**Dominion®**

Serial No. NA3-08-056R  
Docket No. 52-017  
COL/JPH

**DOMINION VIRGINIA POWER**  
**NORTH ANNA UNIT 3 COMBINED LICENSE APPLICATION**  
**RESPONSE TO REQUEST FOR ADDITIONAL INFORMATION LETTER 009**

**NAPS COL 8.2.4-A Figure 8.2-201 500/230 kV Switchyard Single-Line Diagram**

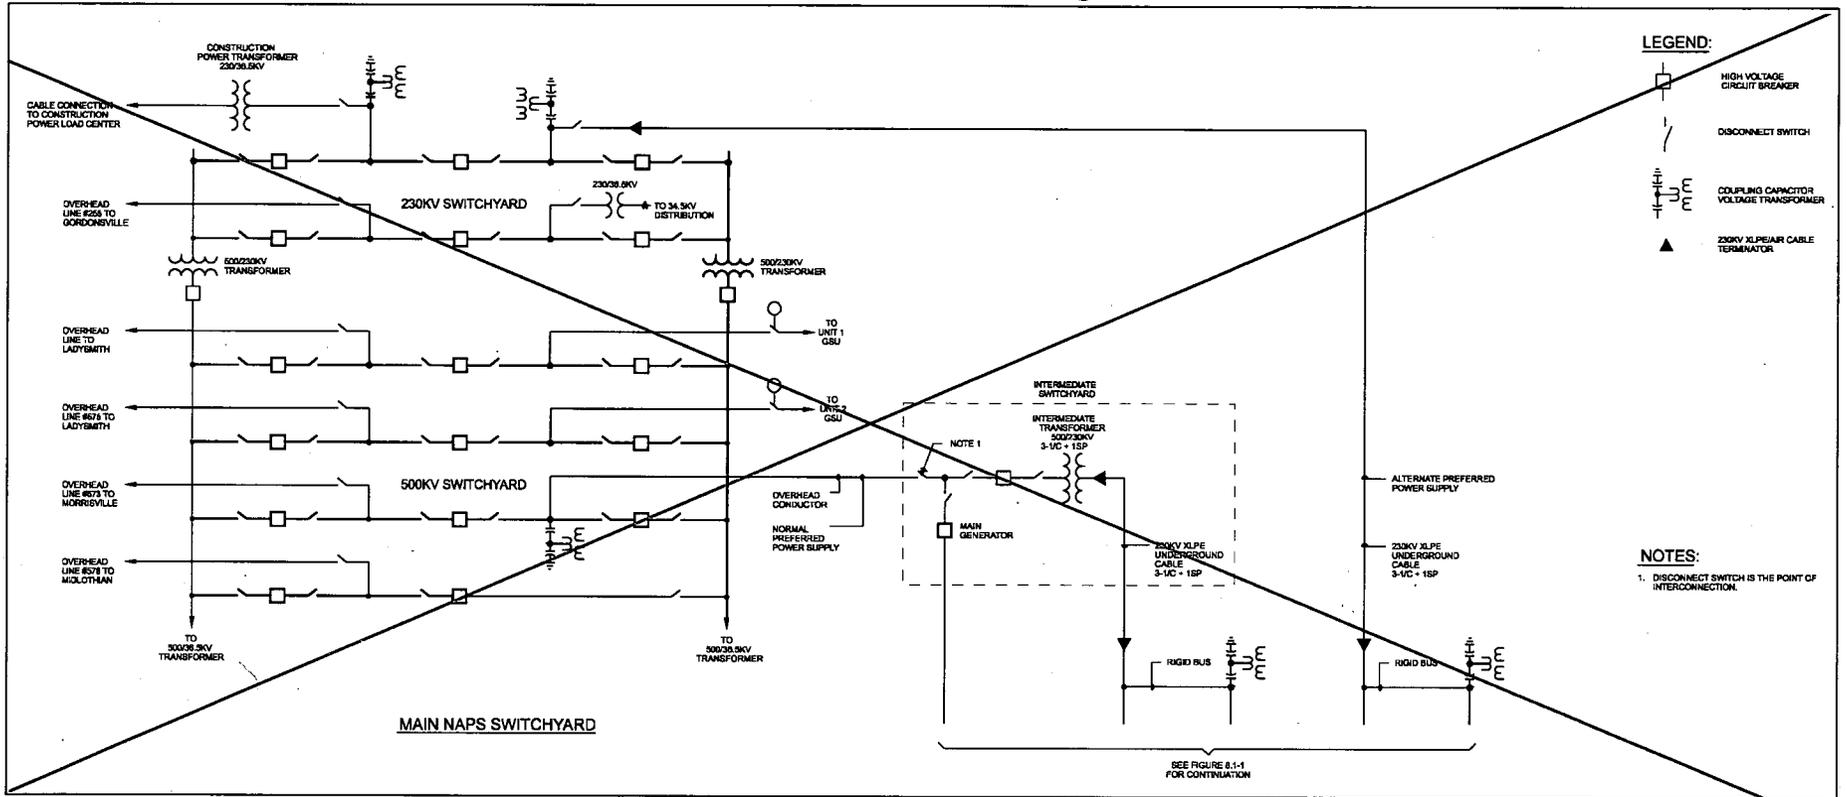
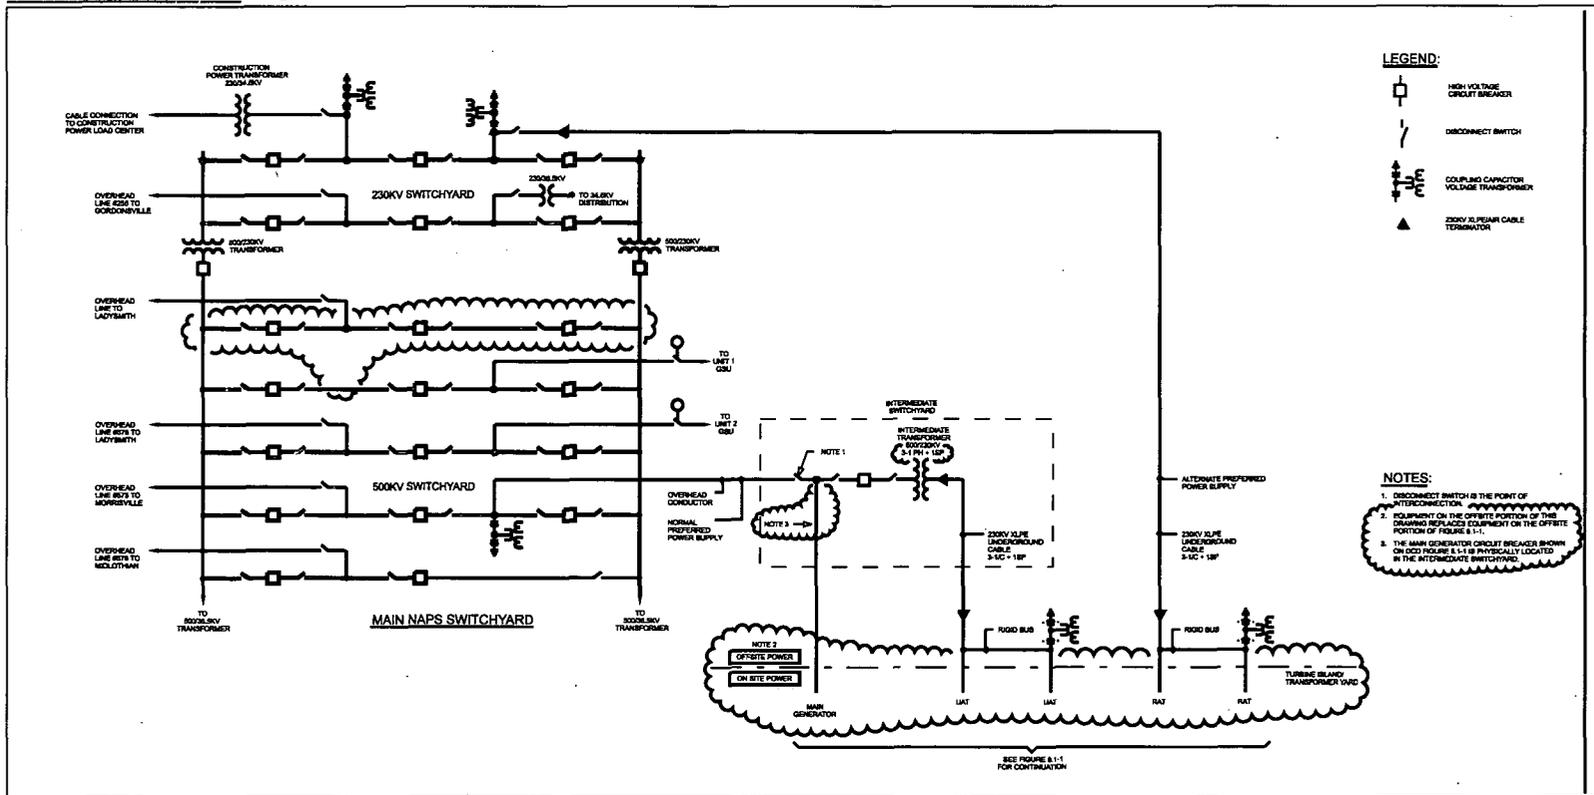
*Staff review of FSAR Chapter 8 Figure 8.2-201 indicates a discrepancy with corresponding DCD Rev. 4 Figure 8.1-1. In Figure 8.1-1, main generator circuit breaker is shown as part of onsite power system while the same breaker is shown in intermediate switchyard in Figure 8.2-201. Also, in Figure 8.1-1, main transformer and unit auxiliary transformers (UATs) are connected at the high voltage side of main transformer; however, in Figure 8.2-201, UATs high side voltage is 230 kV and main transformer's high side voltage is 500 kV and it is not clear how the connection can be made with different voltages. Please clarify the apparent discrepancies.*

DCD Figure 8.1-1 is a functional depiction of the ESBWR electrical power distribution system. The figure correctly shows the main generator circuit breaker as part of the onsite power distribution system. The main generator circuit breaker is physically located in the NAPS intermediate switchyard. FSAR Figure 8.2-201, which depicts the NAPS 500/230 kV switchyard and also shows certain equipment as within the NAPS intermediate switchyard (including the main generator circuit breaker) will be revised to remove the main generator circuit breaker symbol from the figure. A note will be added to clarify the interface between the DCD Figure 8.1-1 and FSAR Figure 8.2-201.

As such, the standard plant design does not specify the voltage level on the high side of the unit auxiliary transformers (UATs) or reserve auxiliary transformers (RATs). Rather, this is a site-specific determination. At North Anna, the high voltage side of the UATs and RATs will be at 230 kV and the generator step-up transformers (GSUs) will be at 500 kV on the high side. Because of this, a 500/230 kV transformer bank will be located in the Intermediate Switchyard to step down 500 kV to 230 kV for use by the UATs and RATs, as depicted in FSAR Figure 8.2-201.

A note will be added to FSAR Figure 8.2-201 to clarify that equipment on the Offsite Power portion of FSAR Figure 8.2-201 replaces equipment on the Offsite Power portion of DCD Figure 8.1-1.

In addition to the 2 notes being added to Figure 8.2-201 as a result of this RAI response, the new 500 kV bay, which ties in the new Ladysmith transmission line for Unit 3, has been added to this figure.

FSAR Figure 8.2-201 will be revised as shown in the attached markup.
